**TOWN OF MOUNTAIN VILLAGE
REGULAR DESIGN REVIEW BOARD MEETING AGENDA
THURSDAY MAY 2, 2024, 10:00 AM
MOUNTAIN VILLAGE TOWN HALL
455 MOUNTAIN VILLAGE BLVD, MOUNTAIN VILLAGE, COLORADO
TO BE HELD HYBRID THROUGH ZOOM:
<https://us06web.zoom.us/j/89545752025>
Meeting ID: 895 4575 2025**

TO: Mountain Village Design Review Board
FROM: Claire Perez, Planner II
FOR: Design Review Board Meeting; May 2, 2024
DATE: April 24, 2024
RE: Consideration of a Design Review: Final Architecture Review for a new Single-Family home on Lot 344R, TBD Rocky Road, pursuant to CDC Section 17.4.11.

TO: Mountain Village Design Review Board
FROM: Claire Perez, Planner II
FOR: Design Review Board Meeting; May 2, 2024
DATE: April 22, 2024
RE: Staff Memo – Initial Architecture and Site Review (IASR) Lot 205A, 112 Stevens Drive.

A1.1

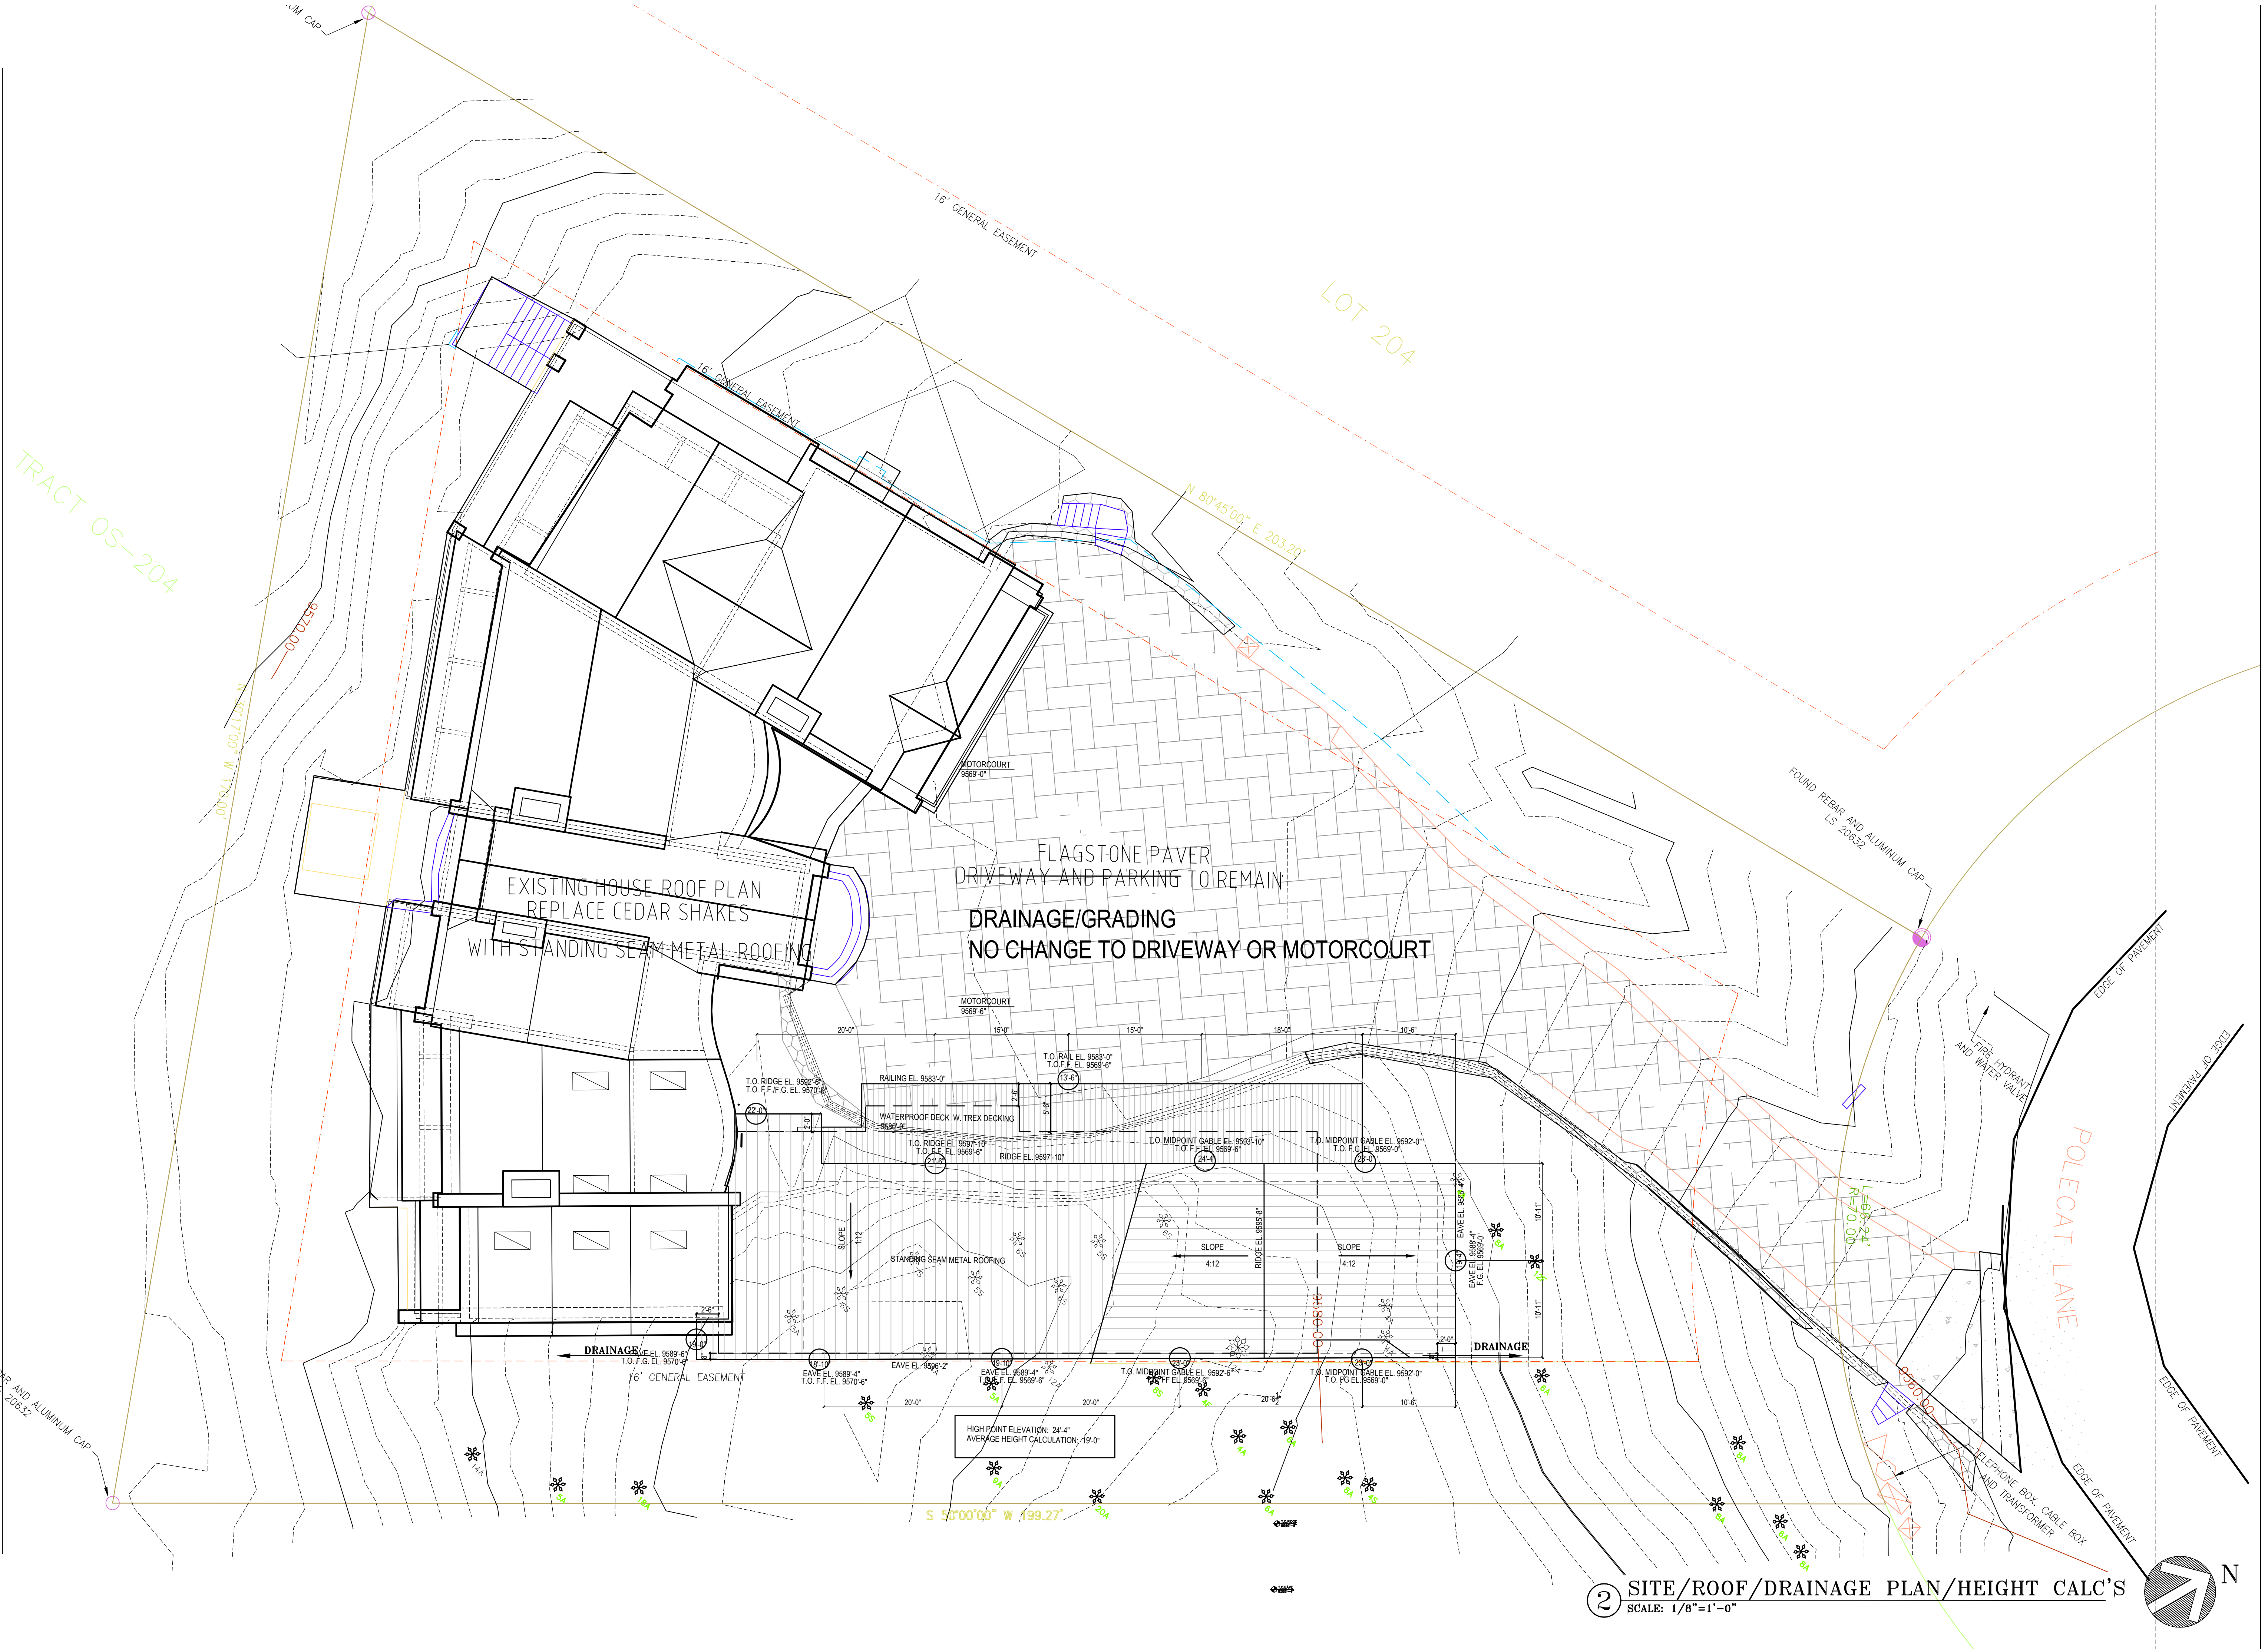
Staff: There is minimal grading proposed near the addition. Existing boulder walls will be removed for development. The applicant should demonstrate the portions of the boulder walls that will remain prior to Final Review. Staff does not see any issues with this grading plan.

Staff: A conceptual landscape plan was provided on Sheet A1.1. The plan notes that the garden area near the entry of the main house will be preserved. The plan does not indicate any new plantings. It should be noted that a full landscape plan is not required until Final Review.

Figure 2: South Elevation

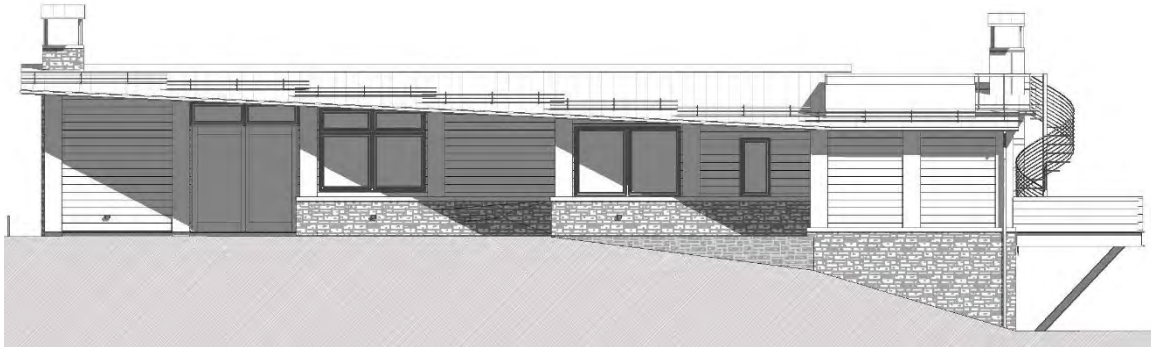
Staff: The primary roof form of the proposed structure is gabled and is therefore granted a maximum height of 40 feet and an average height of 35 feet. The applicant has indicated that the maximum height of the current proposed structure is 45.17 feet and has an average height of 28.46 feet (Sheet A-009 of the attached plan set). The CDC requires that height is demonstrated relative to both existing and proposed grade and that the most restrictive measurements be used to determine height. The applicant has not provided any information on heights as it relates to the proposed grade. The applicant should revise the drawings to demonstrate both existing and proposed grade for each height so staff can determine whether the true maximum and average height is being shown accurately.

Figure 6: Height Analysis 3D Planar View with 40-foot offset

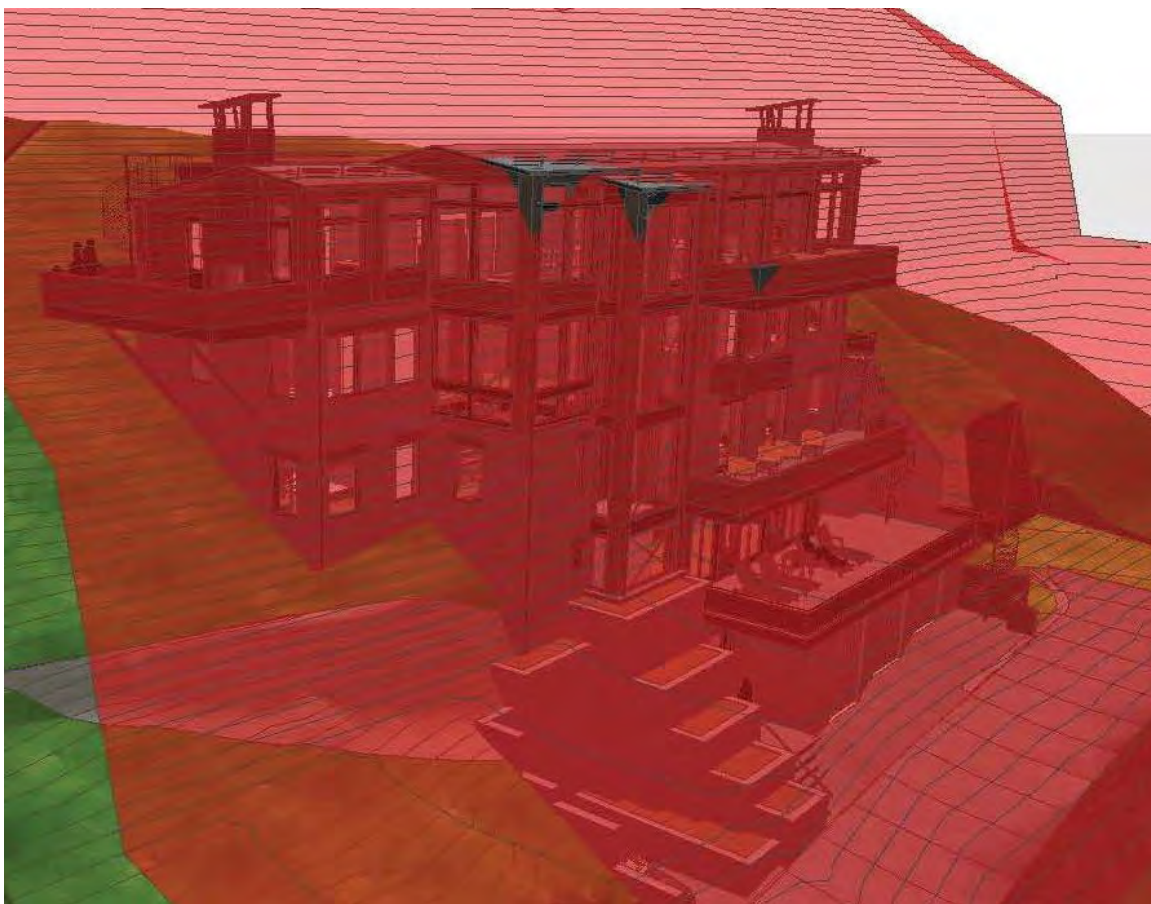
Staff: The DRB has approved height variances before due to unique site conditions related to the slope of a lot. DRB members should discuss whether this variance represents the granting of special privilege in excess of that enjoyed by other property owners. The proposed design also incorporates traditional mining forms that drive much of the overall height, rather than stepping up the slope and staying beneath the 40-foot height threshold. The applicant has significantly modified the design from original plans to reduce the desired height variance through programming of the site, including the relocation of the elevator shaft. The DRB should discuss whether these design elements could constitute special circumstances.

Figure 7: Site Plan – Proposed Parking

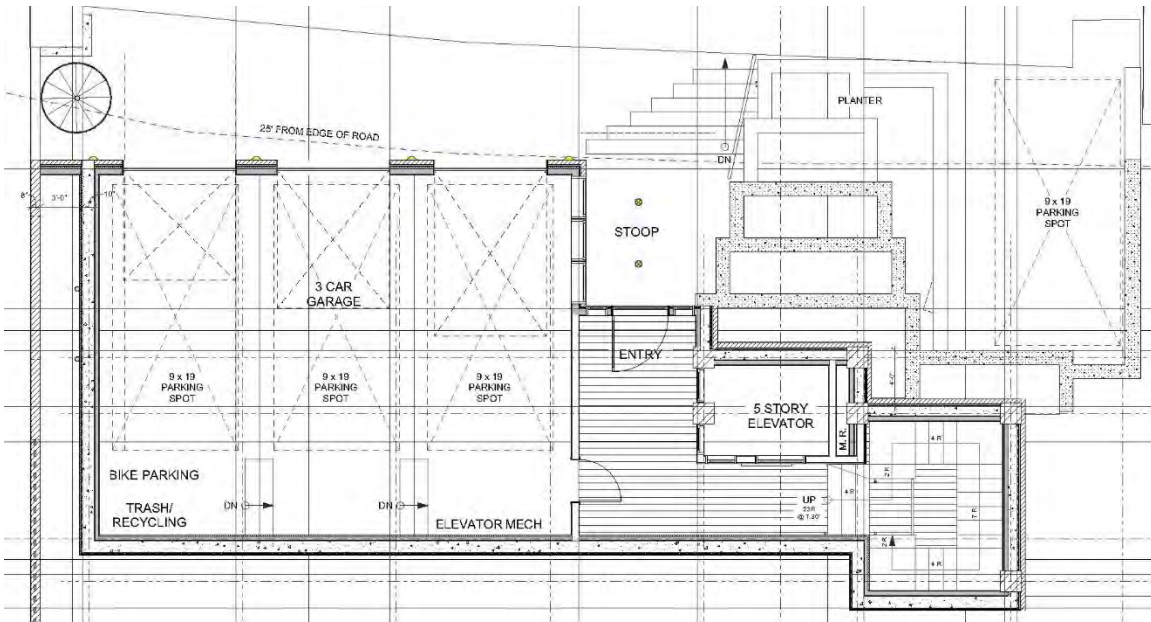
The applicant has indicated that all spaces will be 9' x 18' in size, which meets the standards set forth in the CDC. These spaces are accessed by an 8' wide garage door opening but widen out once inside the garage. Average vehicle widths for cars and trucks commonly seen in Mountain Village (Toyota Tundra, Chevrolet Suburban) are approximately 80 inches wide, or around 6.75 feet. Due to the unique nature of the site, the applicant should be aware of the difficulty in accessing the garages for vehicles of a certain size and turning radius.

Staff: As noted previously, the CDC requires at least 25' of backing space for garages that back out onto the road. This distance cannot be provided for the exterior space due to the unique nature of the site as well as Stonegate Drive/shared access bisecting the lot. Stonegate Drive and the shared driveway access is quite steep and narrow in this location. Prior to Final Architecture Review, the applicant should provide turning movement calculations to show that vehicles can safely enter and exit from the shared access drive into and out of the garages, and may need to look at widening the access to accommodate turning movements.

- 3) *Prior to final review, the applicant shall provide turning movement diagrams that demonstrate the feasibility of vehicles entering and exiting the garage spaces from Stonegate Drive.*

Figure 8: Landscape Plan

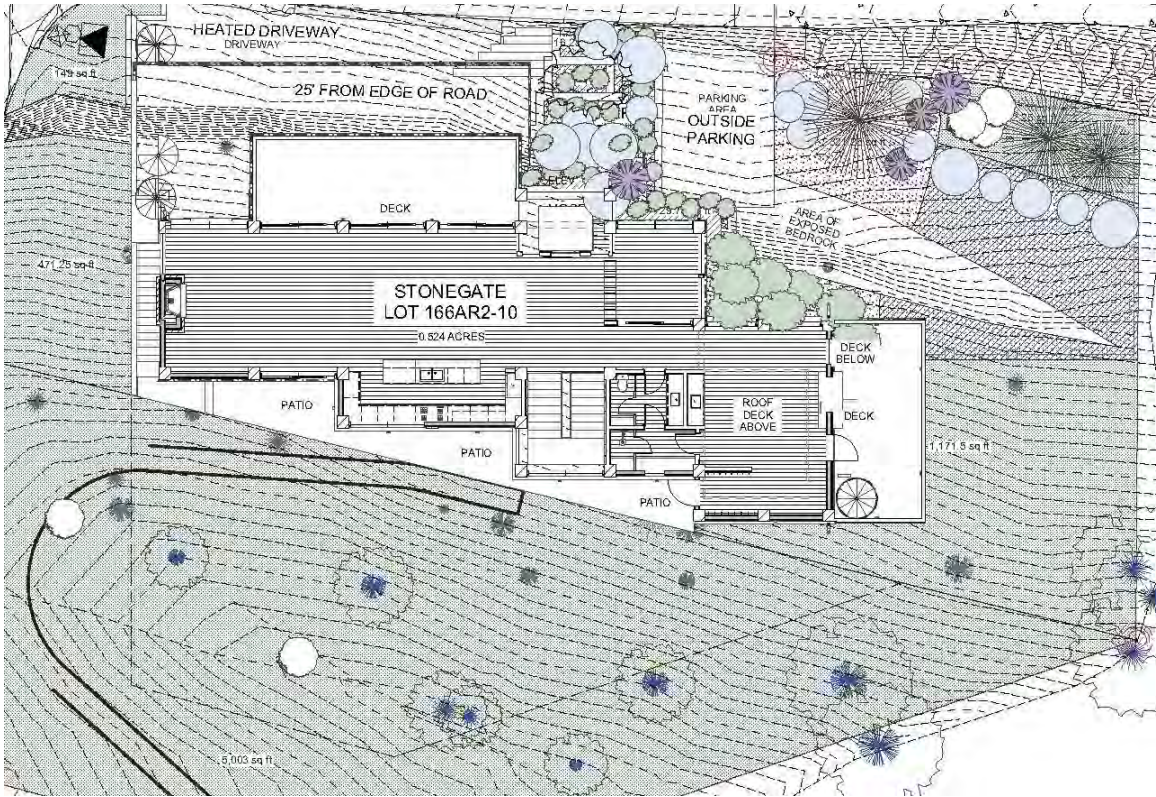
Staff: An initial landscaping plan was provided on sheet A-004 of Exhibit A. The applicant is proposing the addition of 3 evergreen trees, 3 Aspen trees or multi-stems, 1 ornamental Dogwood tree, and 60 ornamental trees or shrubs along with retaining the existing vegetation outside of the Zone 1 fire mitigation area. The revised design also incorporates new planting islands on the north side of the building that would be integrated into the structure.

“The tree that is planned to be installed on the north corner of the home at the bottom of the stairs (Sheet A-004) is located too close to the side of the home and is not recommended by the Town of Mountain Village (current wildfire best management practices state that no vegetation should be installed within 5 feet of the edge of the home (the drip edge of vegetation should be a minimum of 5 feet from the edge of the home).”

“The tree and shrubs planned to be installed right up against or under the south deck of the home are located too close to the deck. According to the CDC, trees must be clear of the home at a minimum distance of 15 feet from the outside edge of the dripline of the building, which includes decks, planters, and patios (with some very specific exceptions, which are not indicated on the Landscape Plan, Sheet A-004). In the event of a wildfire, deck areas are highly vulnerable because they trap swirls of super-heated turbulent currents of air underneath the deck and this is often a location for home ignition. Vegetation and other flammable materials underneath and near decks greatly contribute to this condition.”

All recommendations of the Town Forester should be incorporated into the landscape plan prior to Final Architectural Review.

- 4) *Prior to final review, the applicant shall provide an updated landscape and fire mitigation plan showing compliance with the Fire Mitigation standards and the Town Forester's comments.*
